To: All Plan Holders of Record

Re: Addendum No. 1
WWTP Improvements - REBID
City of Sunbury

Date: December 2, 2024

SCALE	ADDENDUM	SKETCH
N/A	1	SK-1

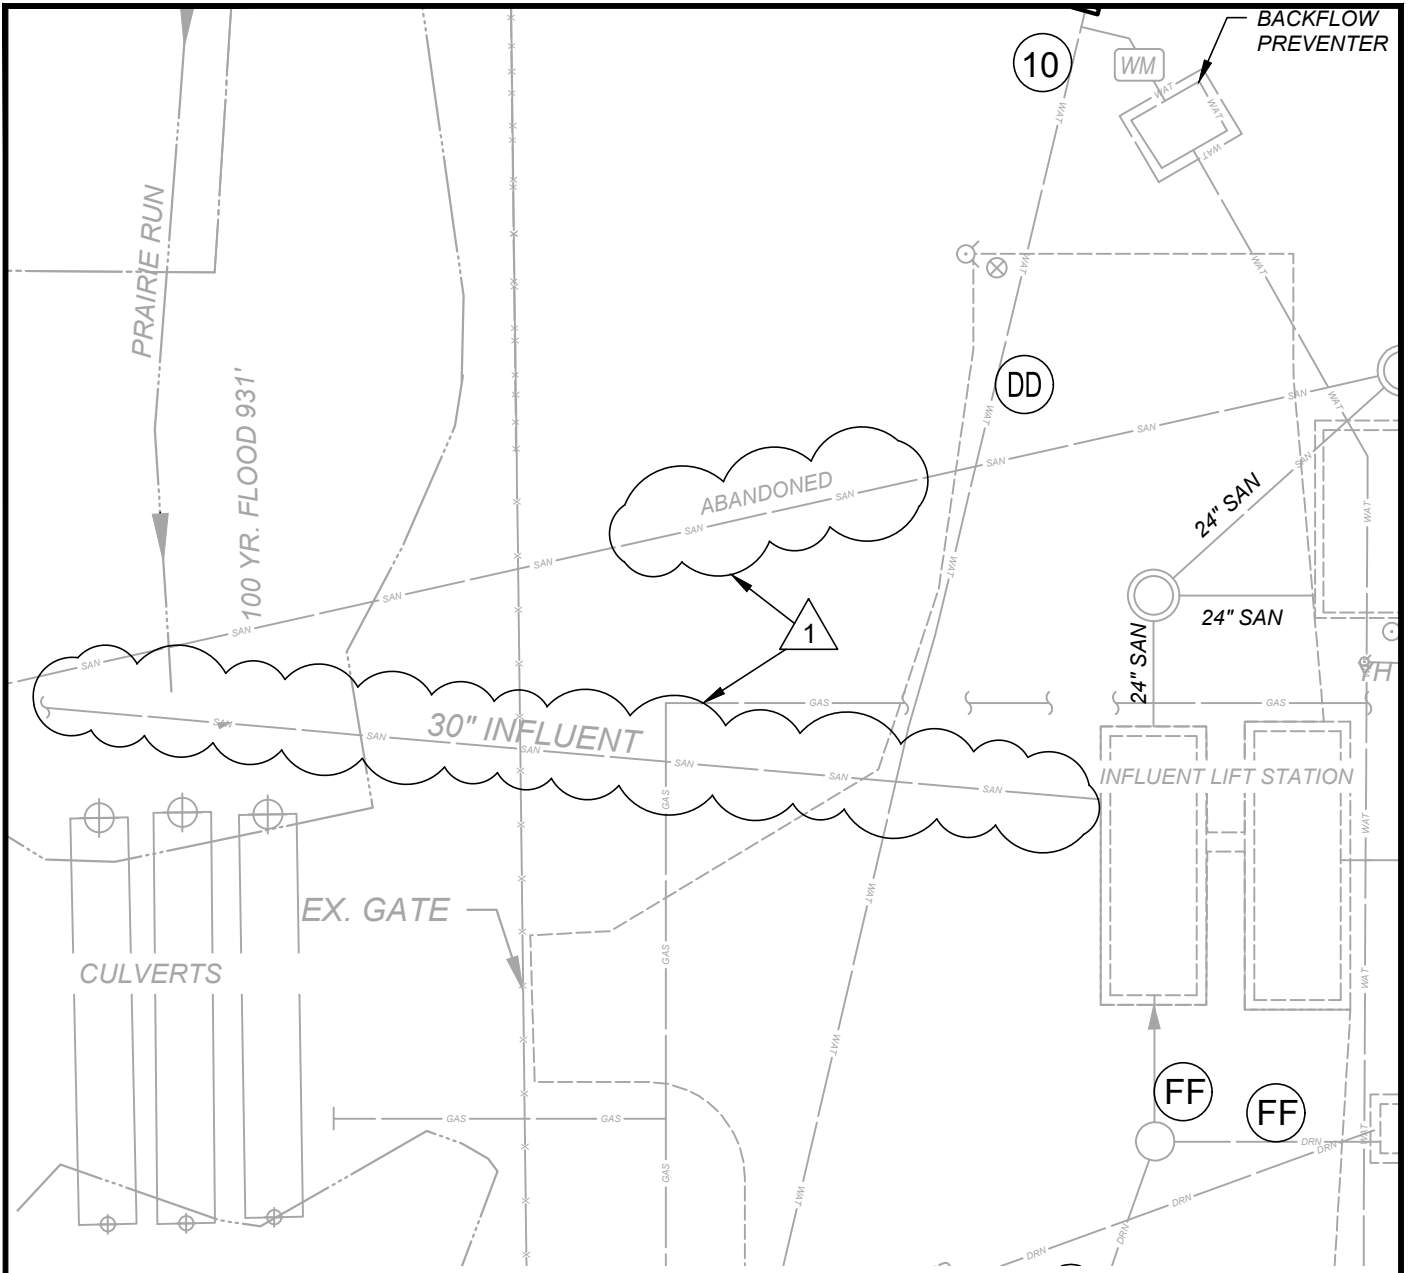
DRAWING 01C-02 – EXISTING SITE PLAN

Add Sketch-1 to show existing 30-inch sanitary sewer line to the Influent Pump Station

NOTE: THIS DRAWING SHALL BE CONSIDERED TO BE A CLARIFICATION OF SHEET 01C-02.

SCALE	ADDENDUM	SKETCH
N/A	1	SK-2

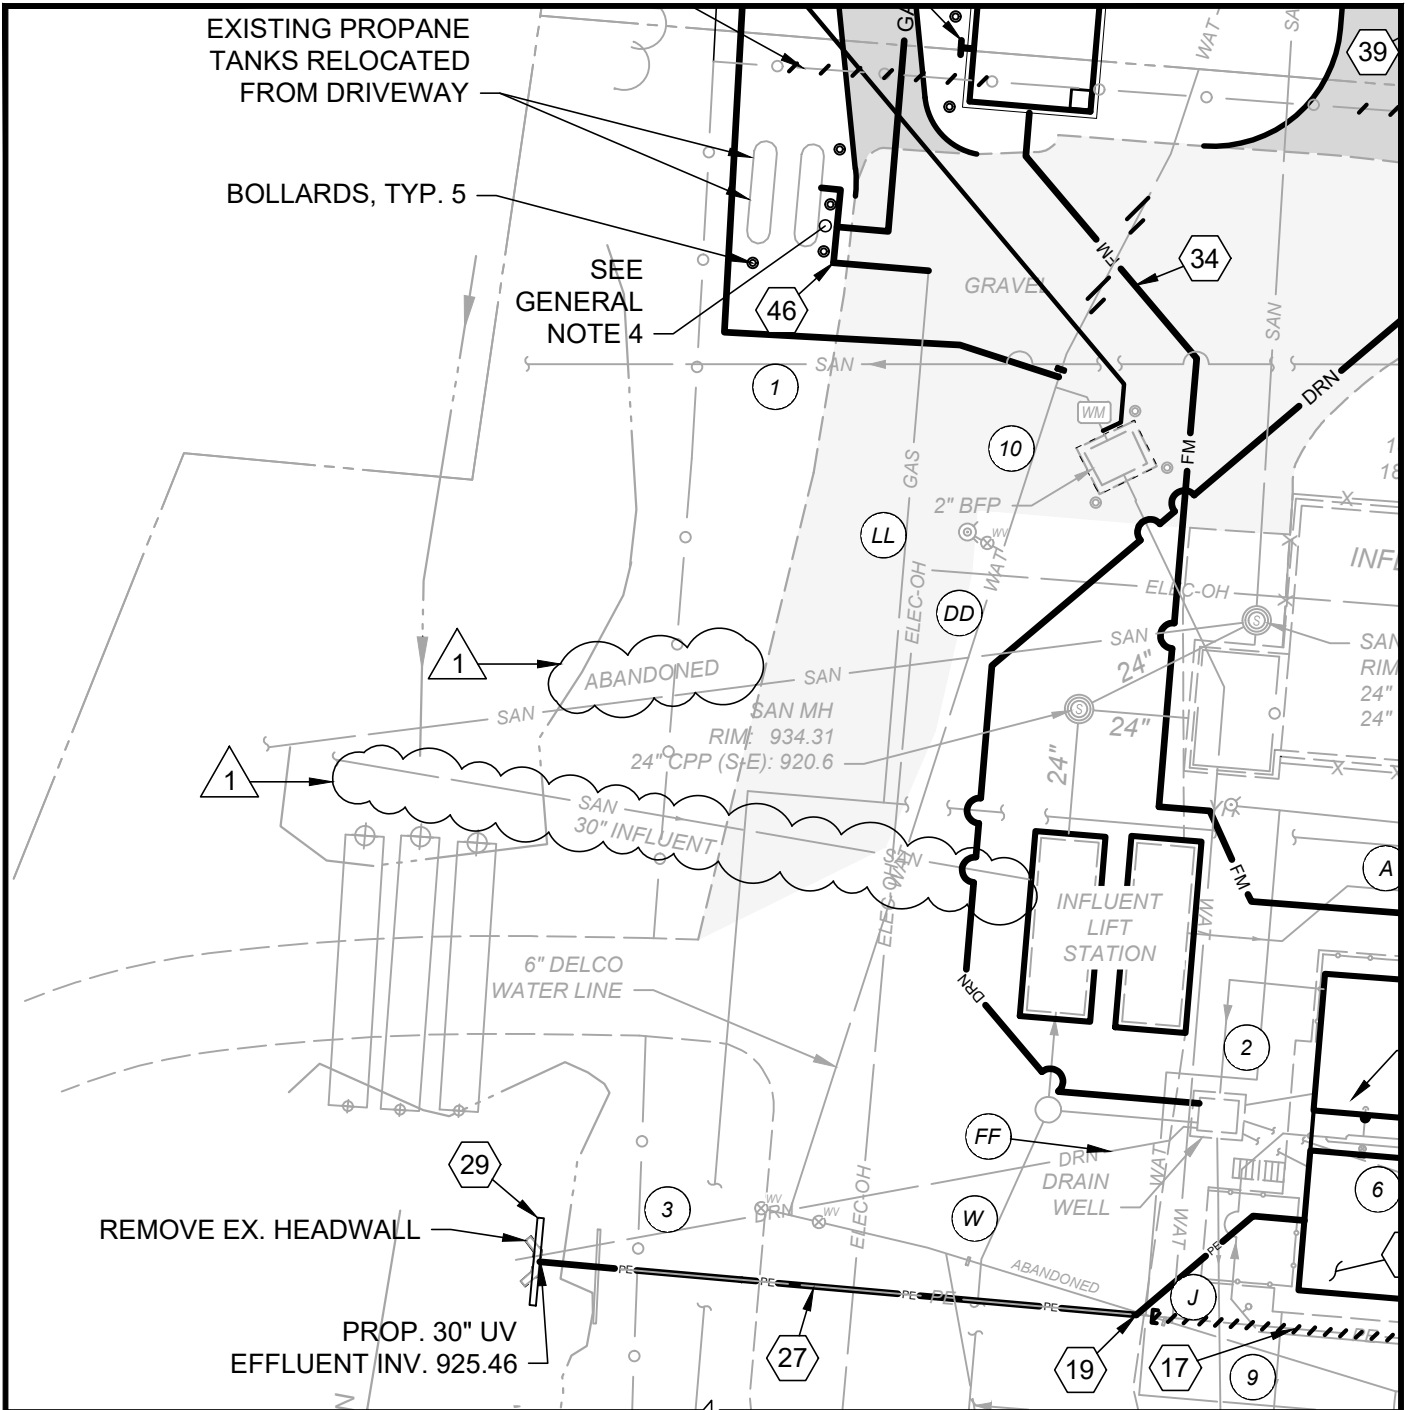
DRAWING 01C-05 – PROPOSED SITE PIPING PLAN

Add Sketch-2 to show existing 30-inch sanitary sewer line to the Influent Pump Station.

NOTE: THIS DRAWING SHALL BE CONSIDERED TO BE A CLARIFICATION OF SHEET 01C-05.
